**Before the
FEDERAL COMMUNICATIONS COMMISSION
Washington, D.C. 20554**

| Advanced Television Systems |) | MM Docket No. 87-268 |
| Existing Television Broadcast |) | Petition for Reconsideration |
| Service |) | of Hammett & Edison, Inc. |

DTV.IXSTUDY™ Analysis Methodology

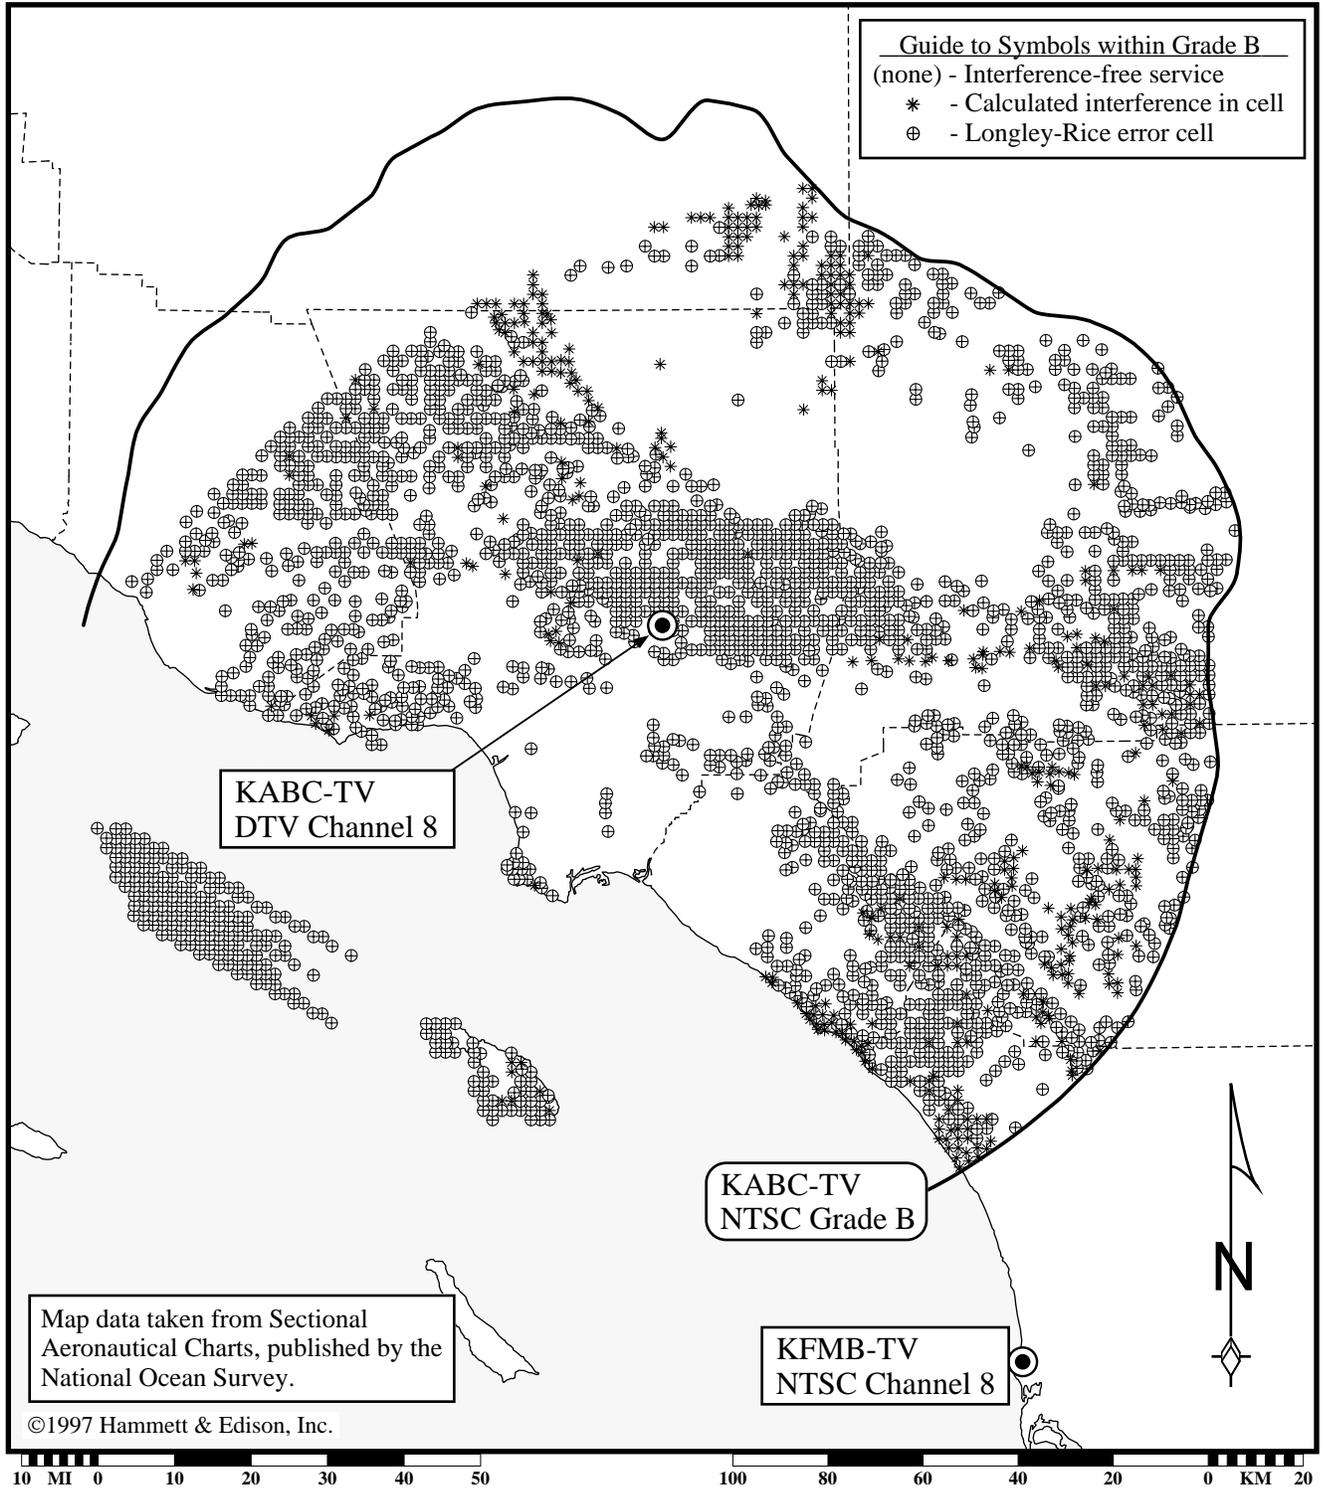
5. The 6RO encourages DTV stations to “maximize” their facilities,¹ with coverage up to that of the largest station within each market, such that no new interference is caused to other stations. In order to provide guidance to our many television clients, we obtained, directly from the FCC’s Office of Engineering Technology, a copy of the computer software program used to generate the DTV allotment table. Once that software was running properly and generating data consistent with that found in the 6RO, Appendix B, Table 1, presenting DTV allotment pairings with analog NTSC stations, the program was modified to serve as an analysis tool to study potential DTV facility changes. This “forward looking” analysis program, as we have dubbed it, is described more fully in Figure 1 attached.

Different Consumer Receive Antenna Patterns, as Assumed
by FCC "Replication" Program to Develop DTV Allotments
– Low-Band VHF –

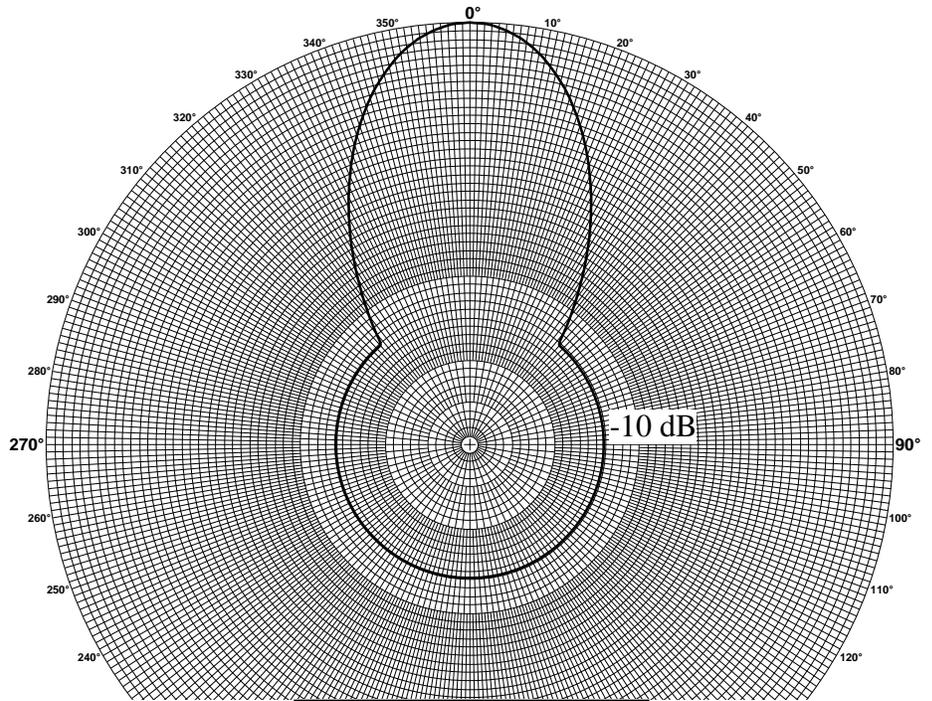
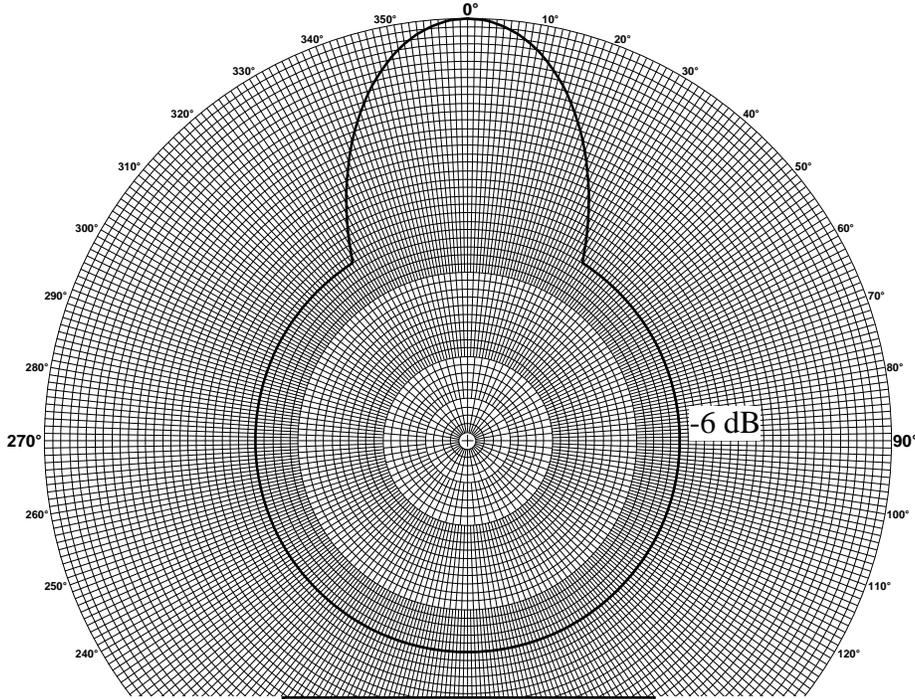
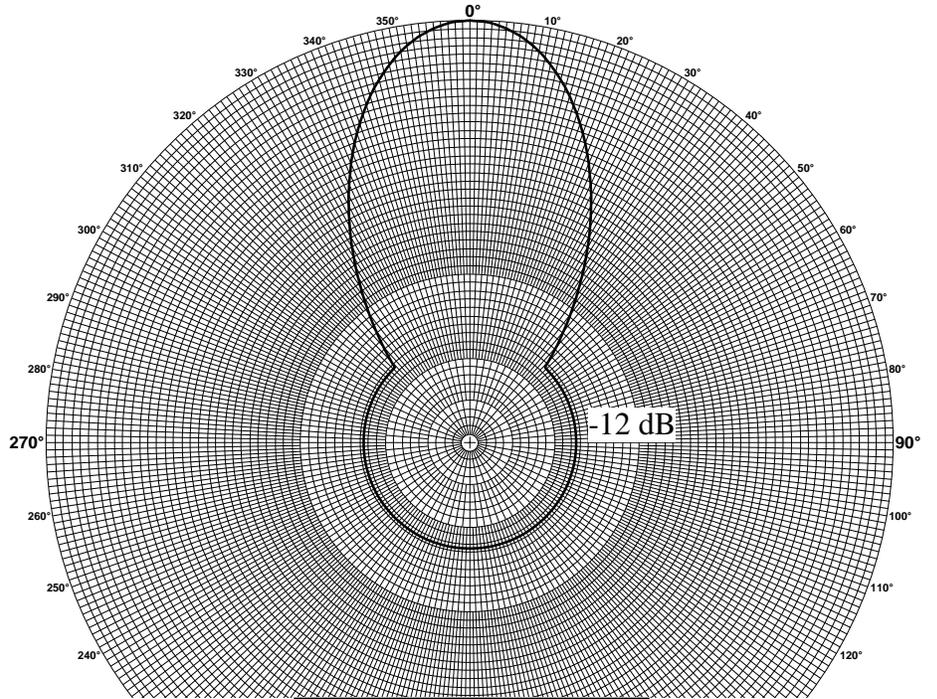
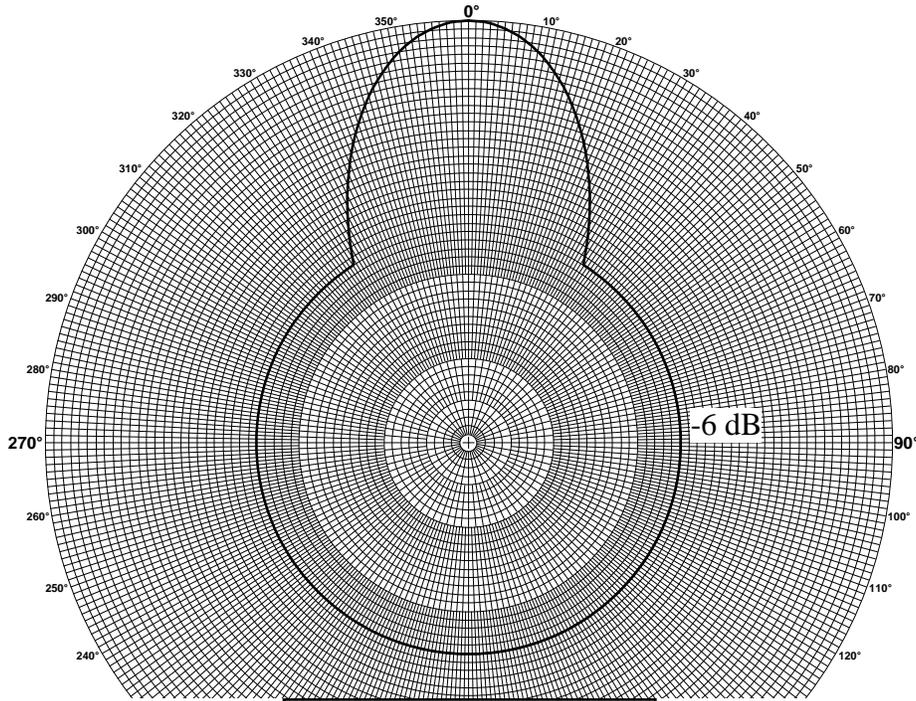
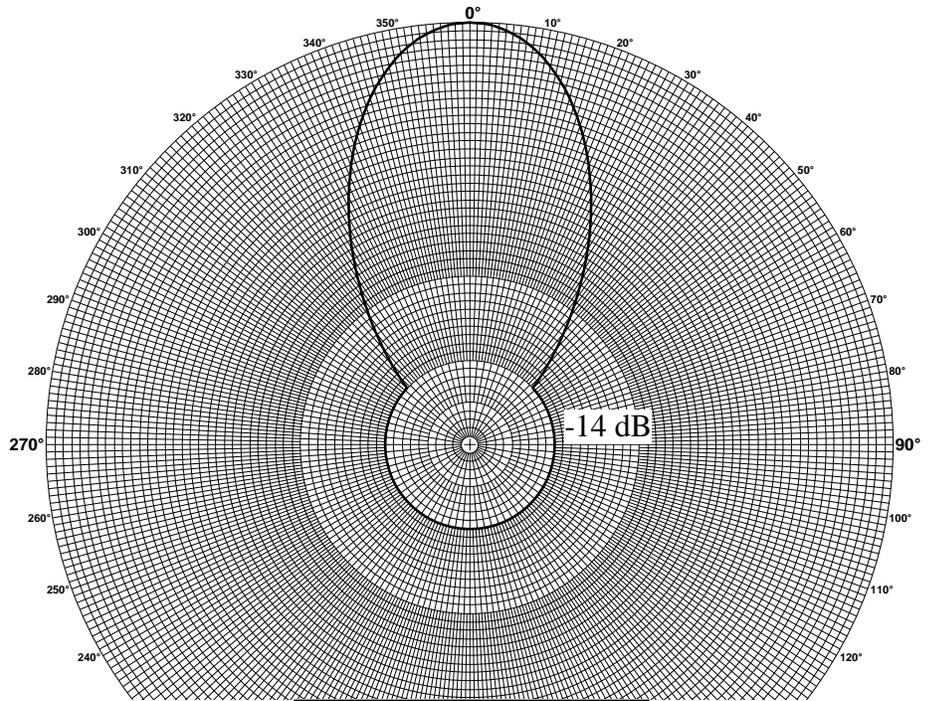
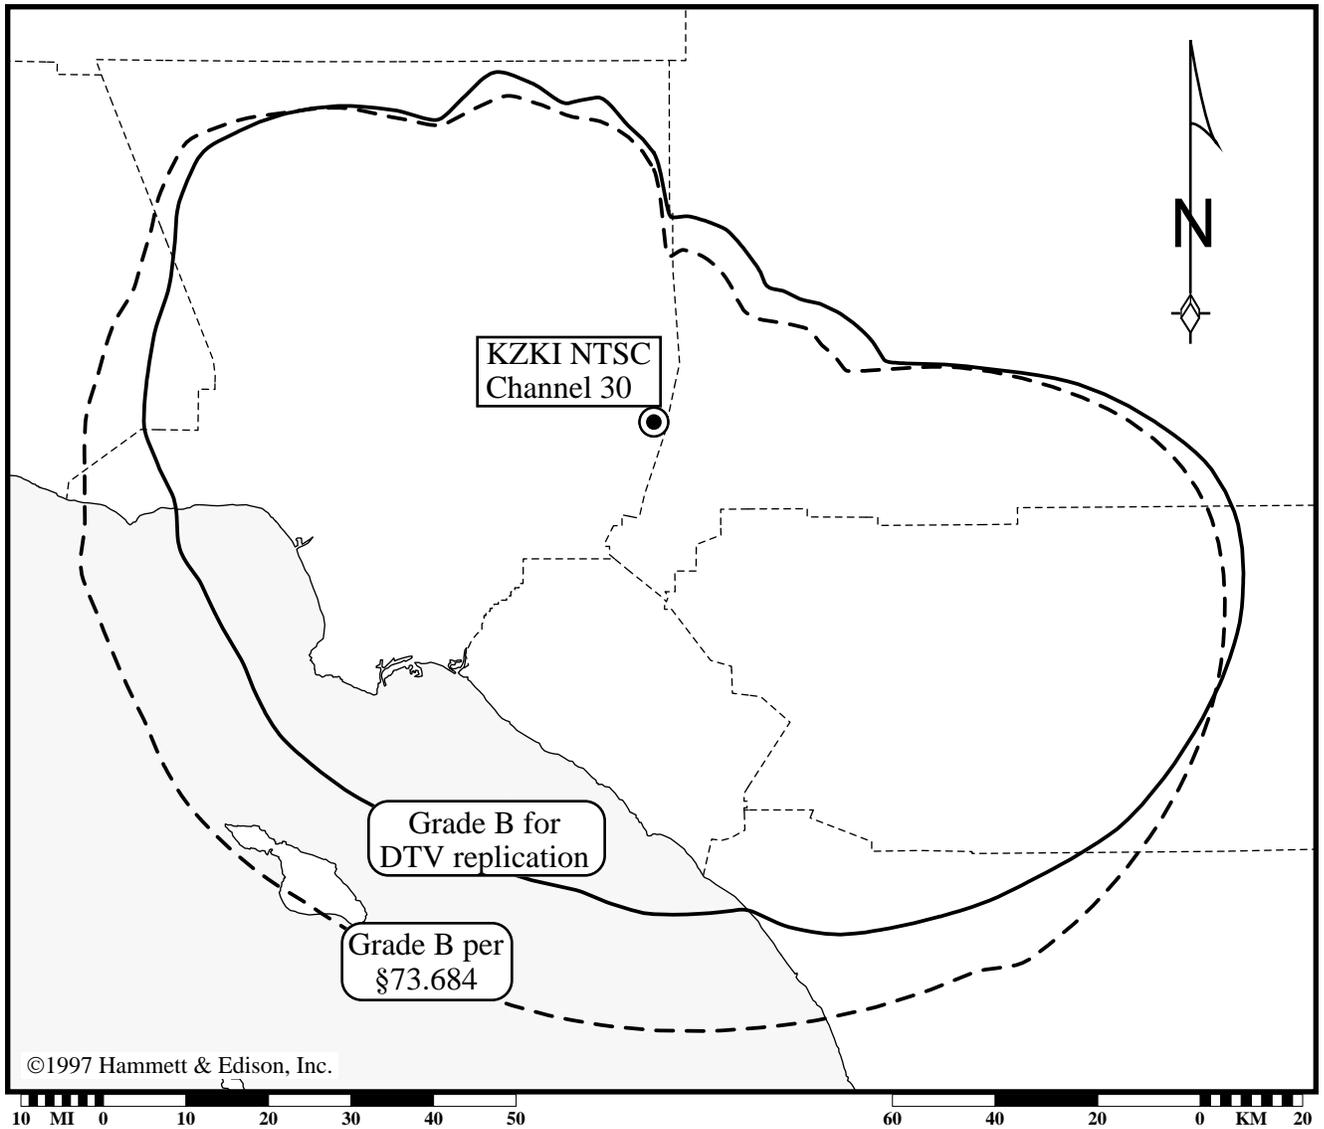
10. The DTV replication program assumed that the consumer antennas used for reception of the DTV signals would be better-performing than the ones used for reception of the NTSC signals, despite the fact that both operations are on the same general frequencies and that no one, in fact, had suggested that consumers would be at all inclined to replace their existing antennas or to install second, larger antennas just for DTV. Evidently, these alternate patterns, included as Figure 3, proved necessary in order to achieve the desired replication numbers. The off-axis rejections (front-to-back ratios) of the DTV antennas are higher, as follows:

However, such antennas would not necessarily be purchased and installed by consumers viewing the DTV stations off-air. In fact, a more reasonable assumption is that they will *not*. Therefore, DTV service will be more interference-limited than assumed and the replication of service will not, in practice, be achieved.
